TRUCK, AMBULANCE, LIGHT, 4 LITTER, FFR, WINCH, MC2 - LAND ROVER 110 6 X 6

REPLACEMENT OF THE AIR CONDITIONER COMPRESSOR MOUNTING BRACKET
TO ENGINE BLOCK MOUNTING BOLTS

MODIFICATION INSTRUCTION

FIG 1 - AIR CONDITIONER MOUNTING BOLTS

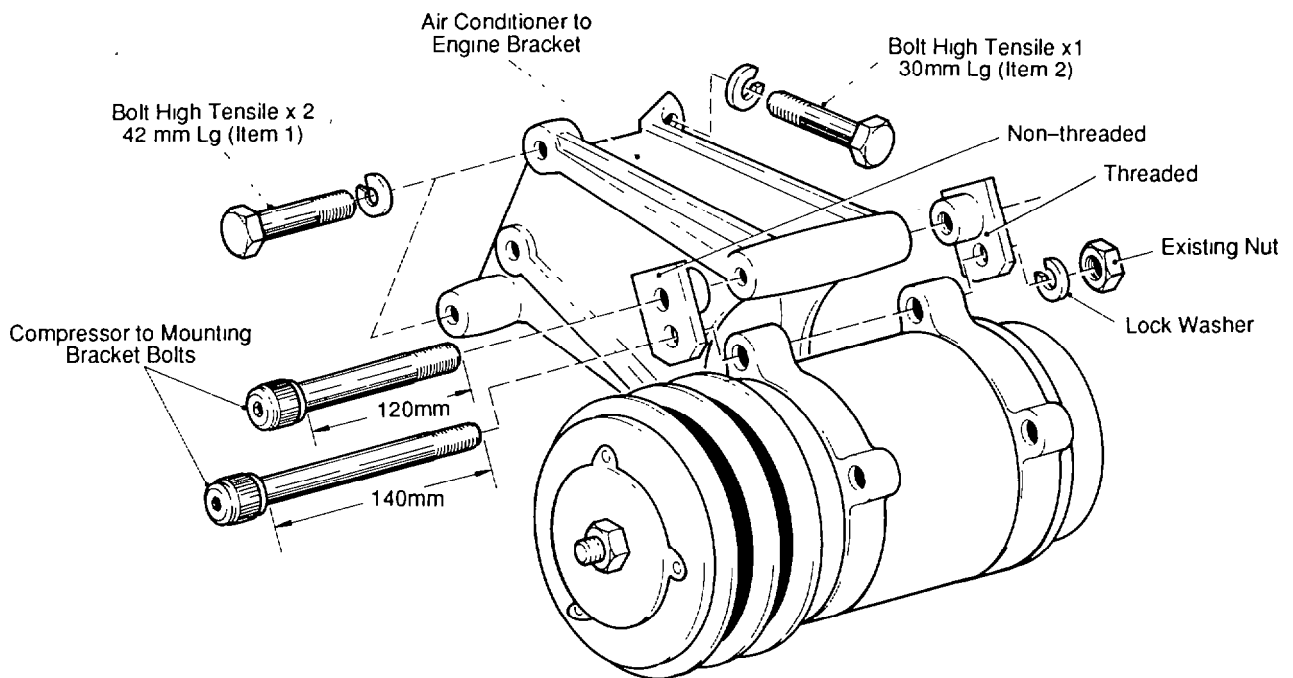
1. This instruction details the replacement of the bolts used to mount the air conditioner compressor mounting bracket to the engine block. The new bolts are high tensile special bolts.

- 1. The air conditioner hoses will not normally be required to be removed, however in the event that hose removal is necessary the instructions in EMEI ELEC T 009-1 are to be followed.
- b. Replace the two existing front bracket to engine mounting bolts (parallel to engine) with new bolts (item 1) after applying Loctite 242 to the threads, as shown in Fig 1.
- c. Replace the rear bracket to engine mounting bolt (90 degree to engine) with a new bolt (item 2) after applying Loctite 242 to the thread as shown in Fig 1.
- d. Torque the mounting bolts to 61 - 68 Nm.
